STAFF REPORT

TO: Planning Commission
FROM: Ashley Monterusso, City Planner
AGENDA ITEM: **Primrose Daycare Conditional Use Permit**
REVIEWED BY: Sophia Jensen, Senior City Planner
Jason Stopa, CD Director

To: Sophia Jensen, Senior City Planner
Jason Stopa, Community Development Director
Marty Powers, Public Works Director
Nate Stanley, City Engineer
Chad Isakson, Assistant City Engineer
Re: Primrose School CUP

TO: ASHLEY MONTERUSSO
FROM: SARAH EVENSON, PLA
RE: PRIMROSE DAYCARE CUP- LANDSCAPE AND TREE PRESERVATION PLAN REVIEW

PROJECT TITLE:	PRIMROSE SCHOOL - LAKE ELMO				
ISSUE NO.:	1				
DESCRIPTION:	SITE PERMIT PLANS				
DATE:	04/10/2025				
PROJECT NO.:	190300279				
DWN BY:	KRM	CHKD BY:	AWD	APPD BY:	JRA
ISSUE DATE:	04/10/2025				
ISSUE NO.:	1				
SHEET TITLE:	GRADING PLAN				
SHEET NO.:	C-301

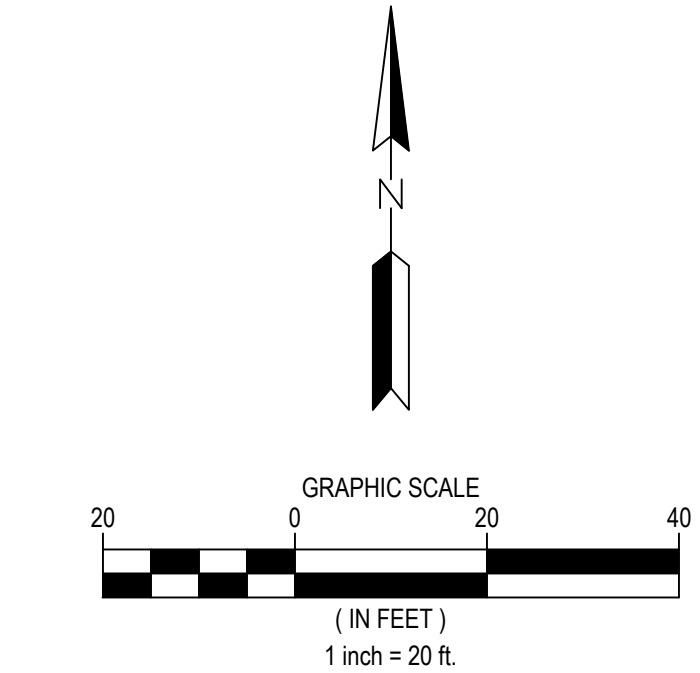
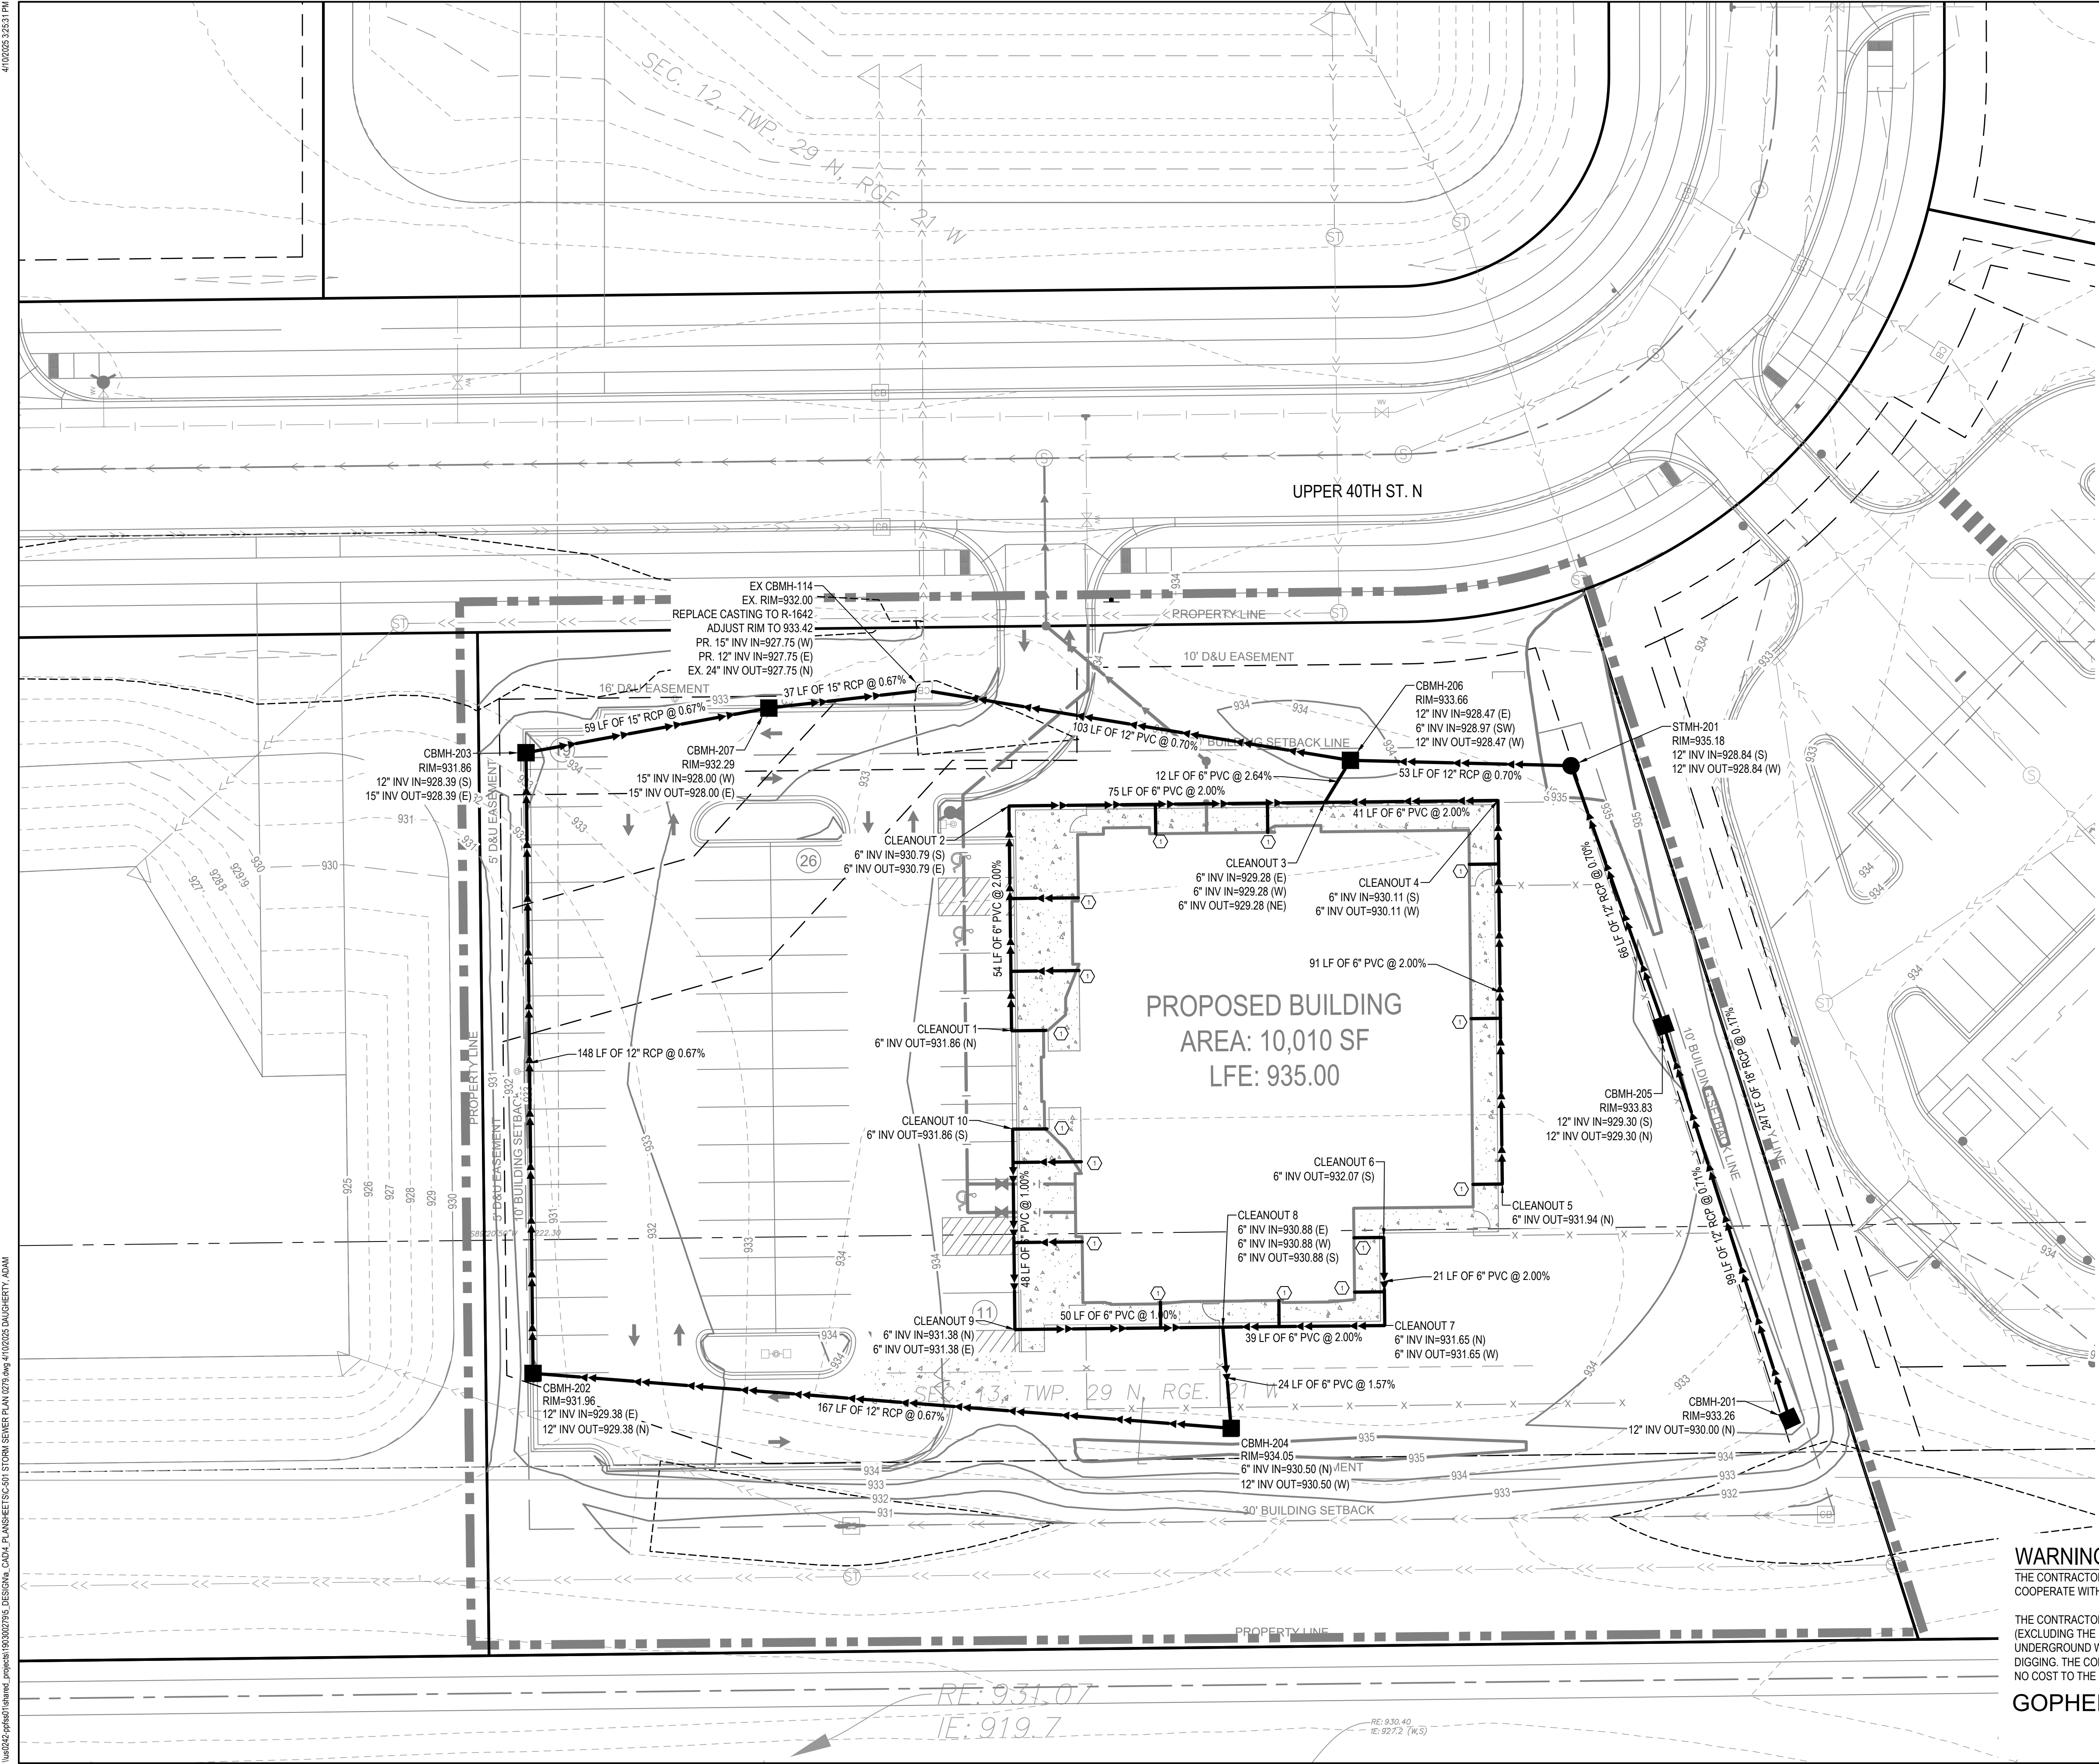
6. C-101. The commercial driveway access location is shown as approved in the Bridgewater Subdivision Improvements.
7. C-301. Site grading will be required to maintain the drainage plan as approved by the VBWD and City for the Bridgewater Subdivision Improvements, including key emergency overflow elevations and flow paths. All emergency overflow elevations must be shown and labeled on the plans.

LANDSCAPE PLAN

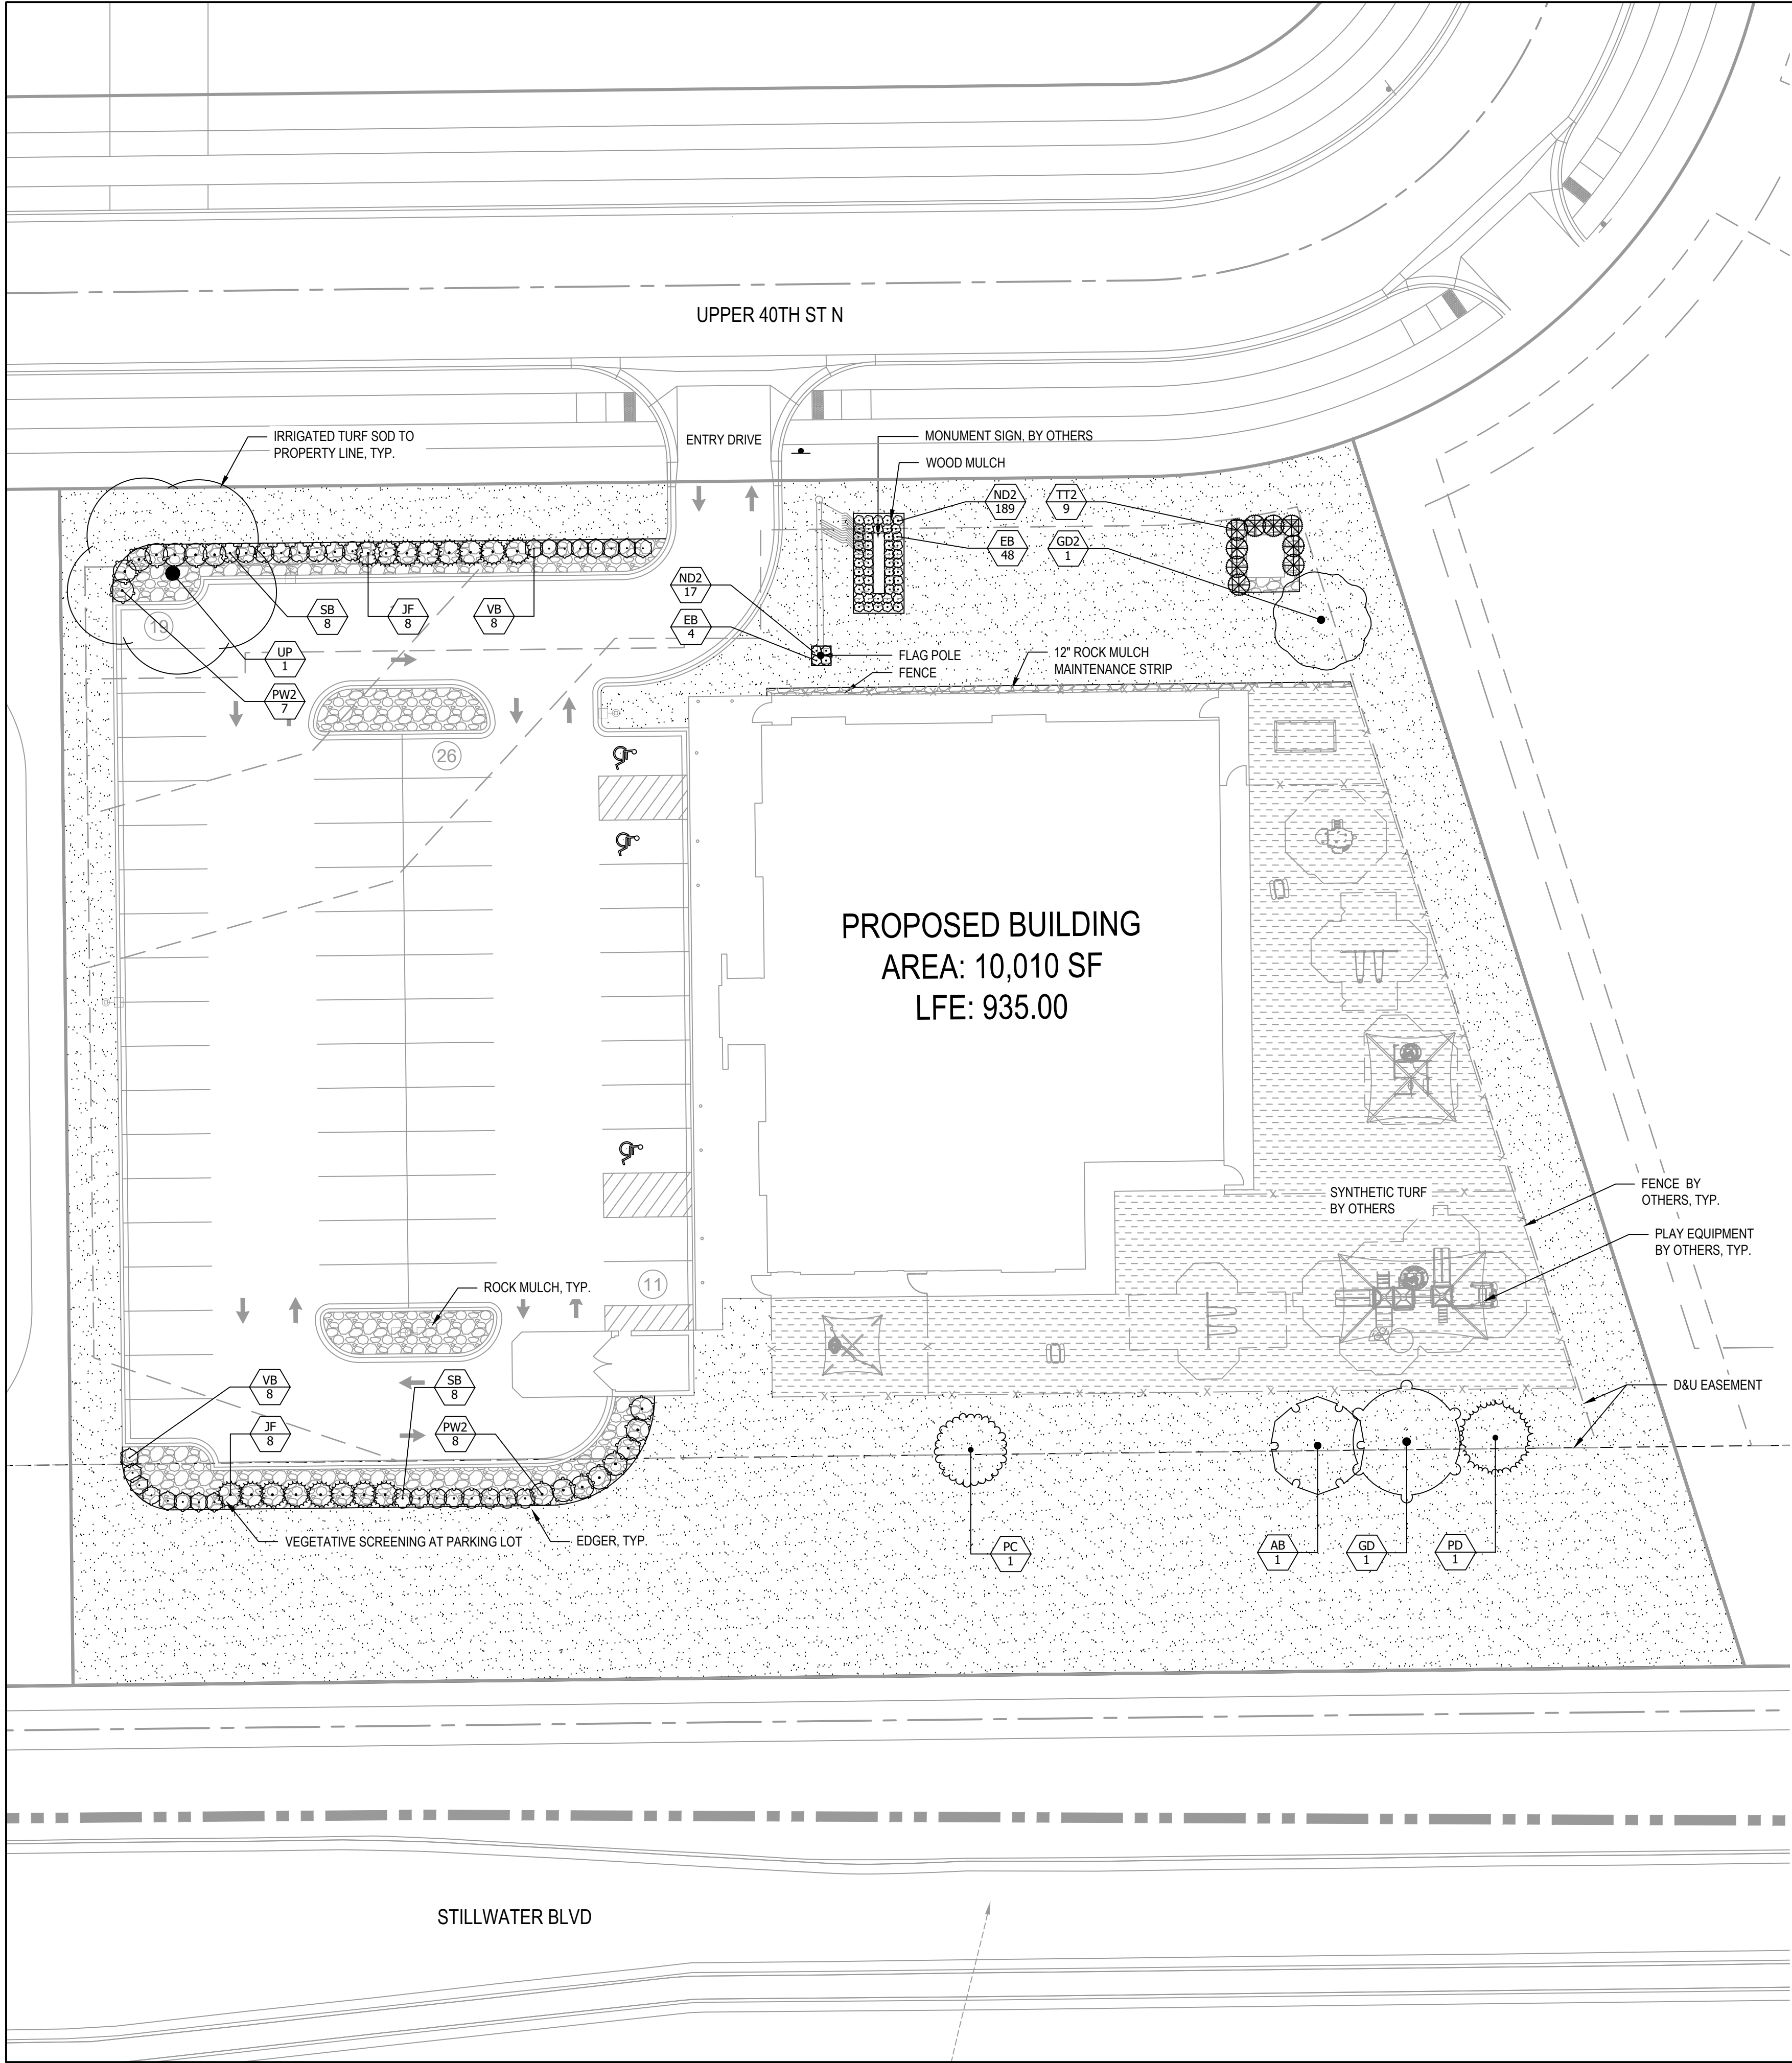
- The landscape plan will need to be revised in order to better meet code. Note the following items:
 - Show the location of a topsoil stockpile on the civil plans

- Interior parking lot landscaping is required, consisting of planting islands, medians, and borders. Per code, “At least five percent of the interior area of parking lots with more than 30 spaces shall be devoted to landscape planting areas. Areas may consist of islands or corner planting beds.”

- Planned landscaping around the parking lot does not appear to meet the 5% minimum threshold. This could be remedied by adding low shrub or perennial plantings to the interior parking lot islands and additional planting around the trash enclosure.

- Per code, the six shade trees required for the parking lot are intended to be provided in islands or corner planting beds, but are currently peppered throughout the site.

- There appears to be room outside of the drainage and utility easements to locate some additional trees, if not all six around the parking lot. Please revise planting plans in an effort to better shade the parking lot where possible.

- In addition to the parking lot trees, 5 trees are required to be planted per acre of land disturbed. The 1.7 acres of disturbance necessitate the addition of 9 more trees.

- If all 15 required trees are not able to be located outside of the drainage and utility easements, please provide a graphic that demonstrates where space is available to plant trees and how many can be reasonably accommodated on site.
- Ensure that with the addition of trees, the plan still meets the minimum tree composition requirements (at least 25% of evergreen and deciduous species).

The landscape plans must be revised and resubmitted to address the items in this memo.
